Red = proposed additions Struck-out = proposed deletions  
 Numbers after additions & deletions refer to Comments in August Matrix [1 - 222] ;  
 [E] refers to EPC Comments; [S] refers to Staff Recommendation

## D. Design Overlay Zone

**Figure D-3: Sightlines - SDP for Building Permit**

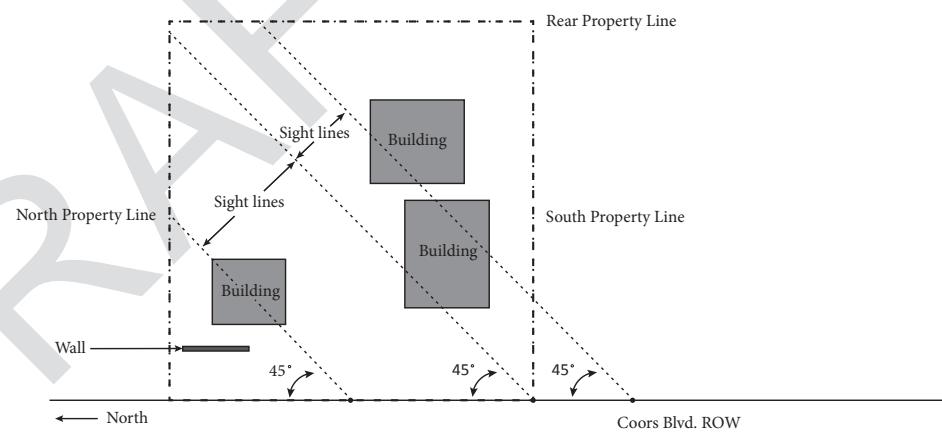
- a. Site Development Plans (SDPs) for Building Permit: Sight Lines are chosen to intersect with the highest features of each structure. As many sight lines shall be established as necessary to capture all of the highest features of structures on the site. [160]

NEW as of October 2014

**Figure D-4: SDP Subdivision - Sites less than 5 acres**

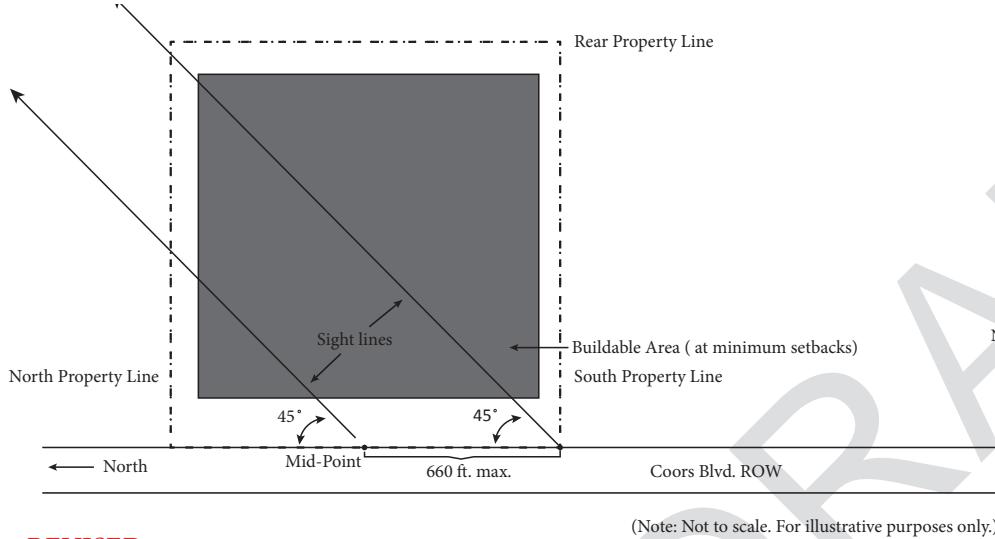
1. Sites of less than 5 acres ~~\*-~~ the point at the southwest corner of the site; and at the mid-point of the property line along Coors Blvd.or at a distance of 660 ft. from the southwest corner, whichever distance is less.

REVISED

**Figure D-5: SDP Subdivision - Sites 5 acres or greater**

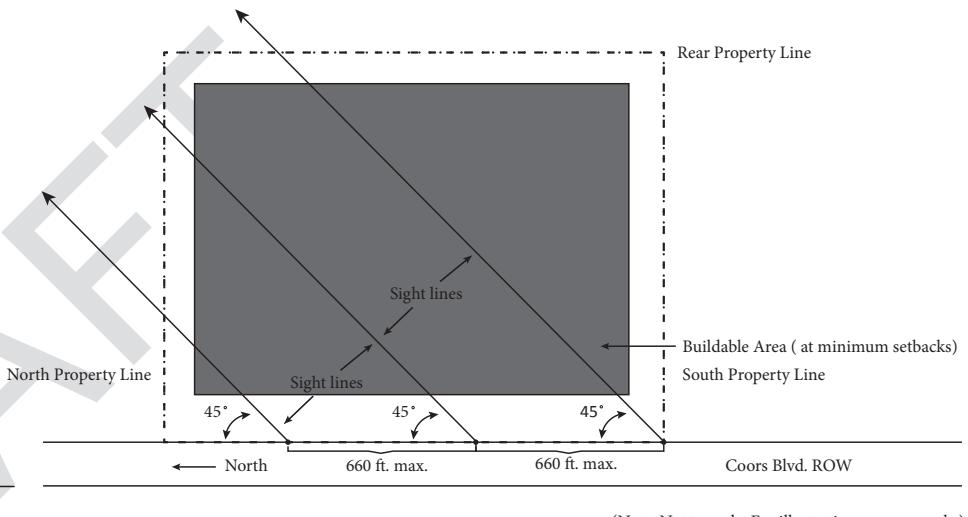
2. Sites of 5 acres or greater ~~\*-~~ the point at the southwest corner of the site; and points at 660 ft intervals along the property line, up to the northwest corner of the site.

REVISED

Figure D-6: Sight Lines and View Area for a Site off Coors Blvd. – Plan View

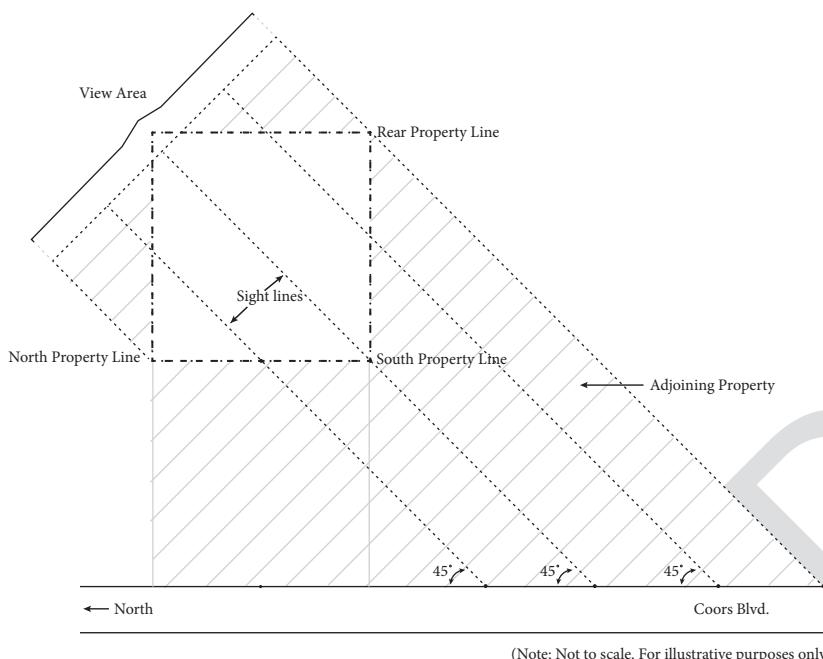
~~\*Note:~~ For sites that are separated from the Coors Blvd. ROW by a platted strip of land forming the landscape setback or that are located further east, the sight lines of the view frames also connect the site with Coors Blvd. at a 45° and their number and location correspond to the application type. [S] of the view frames begin at points on Coors Blvd. that correspond to the southwest corner mid-point as drawn at a 90° angle from the nearest property line of the site to the Coors Blvd. ROW. (See Figure B-1)

REVISED

Figure D-7: View Frames

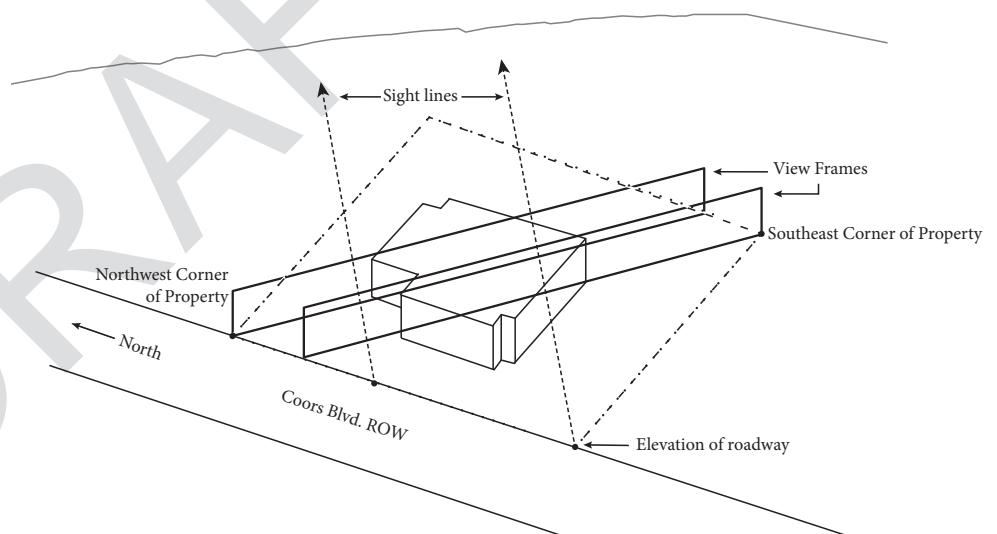
- ii) **View Frame.** A vertical rectangle established at the east edge of the Coors Blvd. ROW, looking toward the Sandia Mountains. drawn at 90° to a given sight line. The top of the view frame is established by the highest point of the Sandia ridge-line in the view frame. The bottom of the view frame is the elevation of the Coors ROW at the point where the sight line begins. The left and right edges of the view frame are an upward projection of the property lines that form the perimeter of the site, where the view frame touches the property lines. Together, the view frames must capture the entire horizontal expanse of the site, i.e. from the northwest to the southeast corners. [161]

NEW as of August 2014

**Figure D-8: View Area with Structures (Site Development for Building Permit) – Plan View**

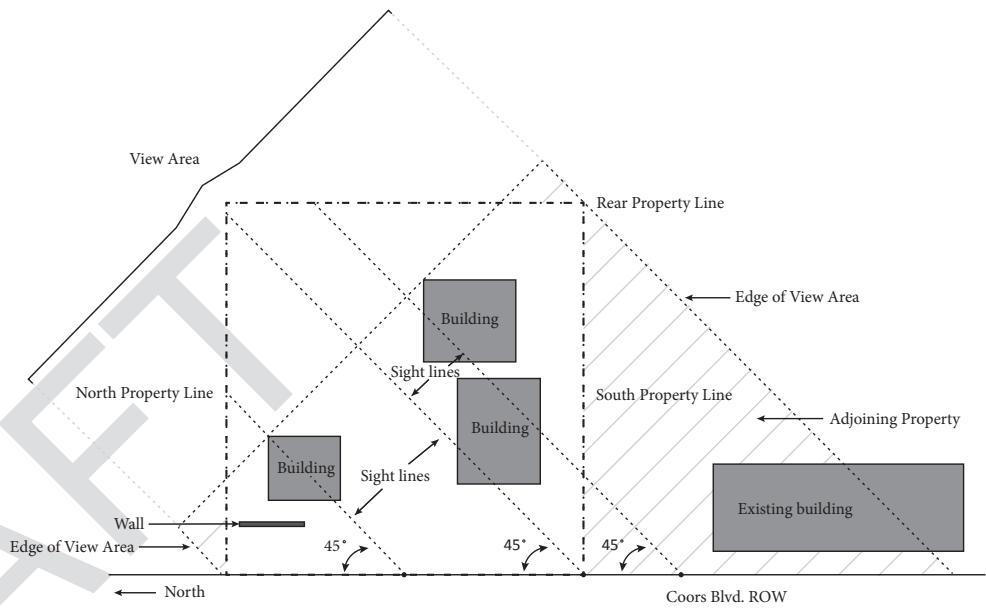
- iii) *View Area.* The view area consists of two or more view frames for each site, depending on the size and shape of the site. The view area must encompass the entire horizontal expanse of the site, i.e. from the northwest to the southeast corners. Two situations are shown in the following diagrams: 1) a building permit application or site development plan for building permit; 2) a site development plan for subdivision. [S]The bottom of the view area is formed by the elevation of Coors Blvd. The left and right edges of the view area are created by vertical extensions from the north and south boundaries of the site. The highest point of the ridgeline of the Sandia Mountains visible between the left and right edges of the view area forms the top of the view area.

REVISED

**Figure D-10: View Frames and View Area for SDP for Subdivision – Plan View**

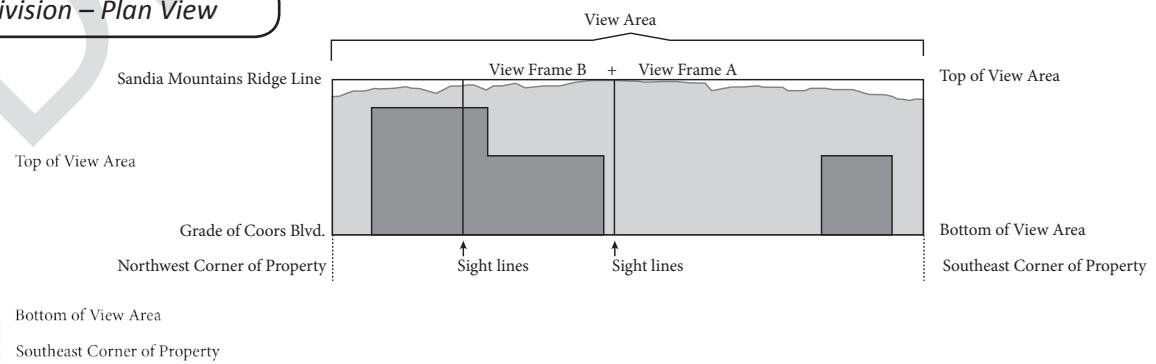
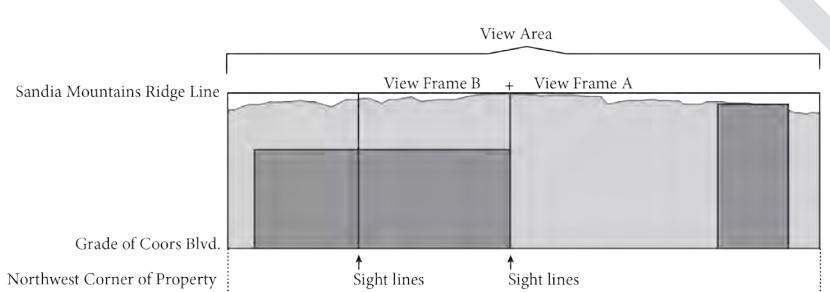
**REVISED**

Figure D-13: Structure Mass

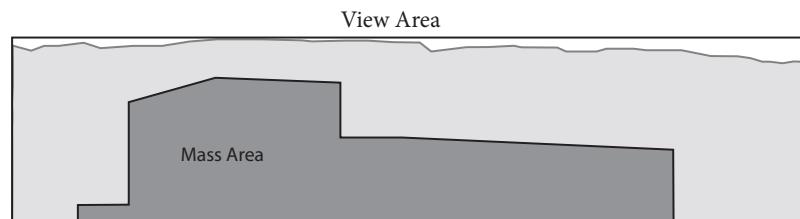
NEW as of August 2014

- v) *Mass.* The mass or bulk of the structure(s) on a site that is visible within the view area. This visual mass is measured as an area in proportion to the total view area. [167]

**Figure D-14: View Windows - Two Concepts**

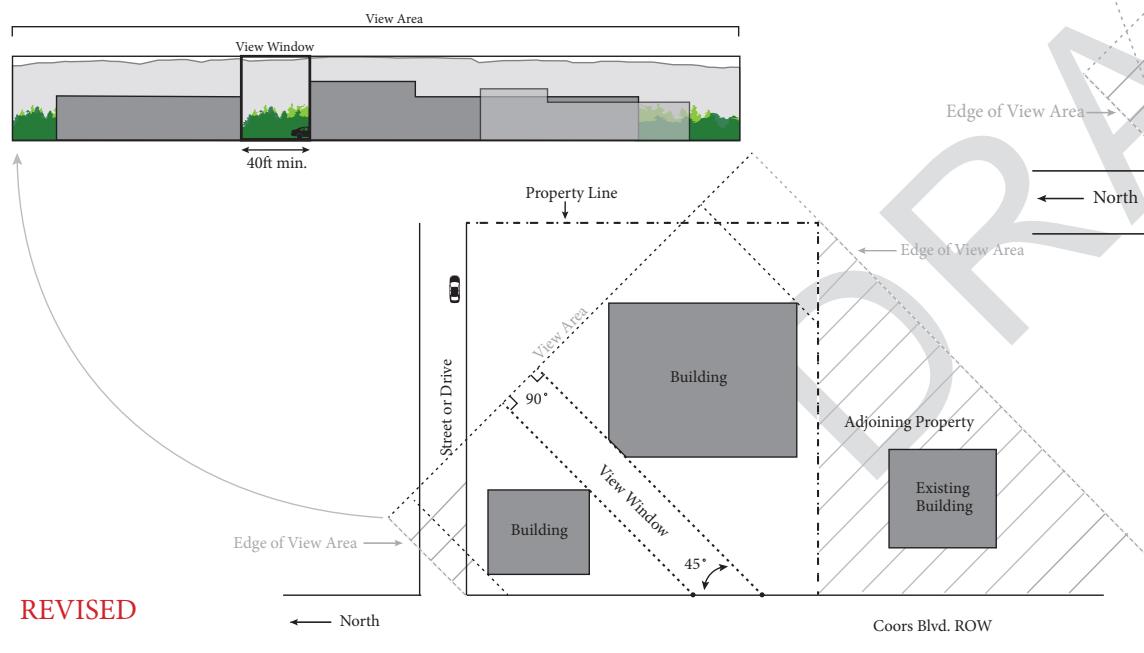
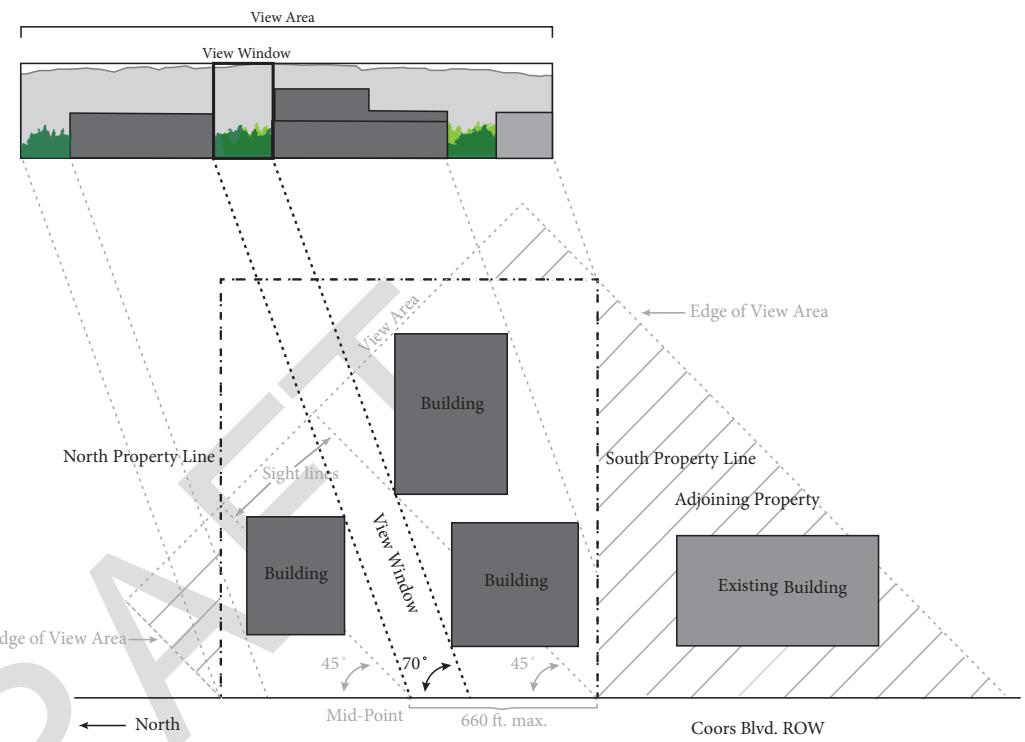
- vi) **View Window.** Consists of a vertical portion of a view area that provides an unobstructed view of the Sandia Mountains, and provides a view of the bosque to the extent possible. The direction of a view window may be at an angle between 45° and 90° (inclusive) from the alignment of Coors Blvd. **View windows apply only to properties north of Paseo del Norte.** [156, 166]

**REVISED**

**Figure D-16: Structure and Visual Mass in VP sub-area**

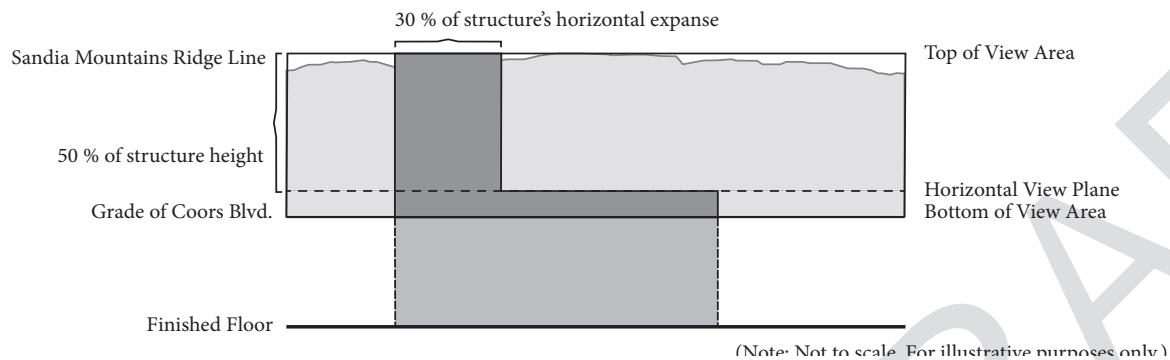
- a. No more than 30% of an individual structure's width horizontal expanse, as seen in the *view area*, [149] shall penetrate above the horizontal view plane as seen in the *view area*.
- b. The visual mass of [S] All the structure(s) on the development site shall obscure no more than 50% of the *view area*.

**REVISED**
